May 17, 2018

Mr. James Kwon  
Product Manager  
ENERGY STAR® for Consumer Electronics  
United States Environmental Protection Agency  
[displays@energystar.gov](mailto:displays@energystar.gov)

As such, we believe we are in a strong position to provide recommendations that will increase participation and adoption among commercial signage display manufacturers and we sincerely appreciate the opportunity to provide feedback on the Draft 1 Version 8.0 ENERGY STAR Displays specification. Our feedback and resulting recommendations are outlined below.

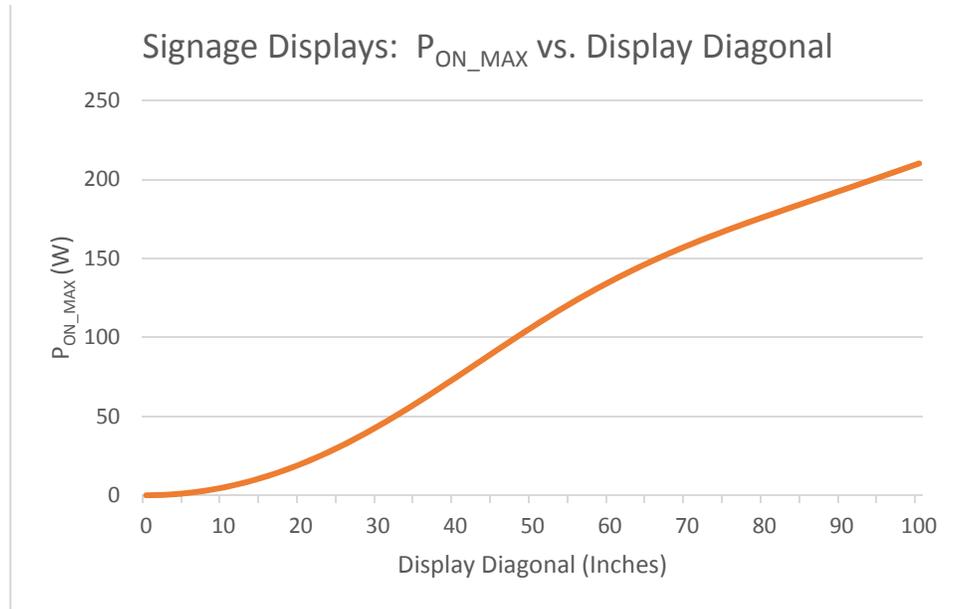
**Maximum On Mode Power ( $P_{ON\_MAX}$ ) is too restrictive for larger displays**

Because of the usage of the hyperbolic tangent function in calculating the Maximum On Mode Power, the rise in  $P_{ON\_MAX}$  continuously decreases as the display diagonal increases, starting at a display diagonal of about 43". For larger displays, this means a disproportionately low percentage increase in  $P_{ON\_MAX}$  compared to the percentage increase in display area. For example, an 85" display has 28.4% greater area than a 75" display, but the total increase in  $P_{ON\_MAX}$  is only 10.3%. The graph below reflects this disparity.

We have observed that displays with a diagonal greater than 75" have substantial difficulty in meeting the P<sub>ON\_MAX</sub> requirements listed in Section 3.4.1 of the draft standard. Accordingly, as of the time of this writing, only 2 of 180 signage displays listed on the ENERGY STAR website are above 75", representing a very small percentage of total displays in that size category. We believe that signage display participation in the ENERGY STAR program would increase if the P<sub>ON\_MAX</sub> requirements were relaxed to be more representative of available large format display power efficiency.

1. Increase  $P_{ON\_MAX}$  for signage displays such that it meets the following criteria:
  - a. The rate of increase in  $P_{ON\_MAX}$  is more closely related to increase in area.
  - b. The overall  $P_{ON\_MAX}$  value for a larger display is fair in comparison to multiple tiled displays that comprise the same area.
2. Create a specific product class for tiled displays with off board processing, potentially with similar Maximum On Mode Power requirements as comparably sized signage displays. As the overall area of these tiled displays can vary considerably between installations, we propose definition of separate power consumption criteria for the processing and display components of the system.
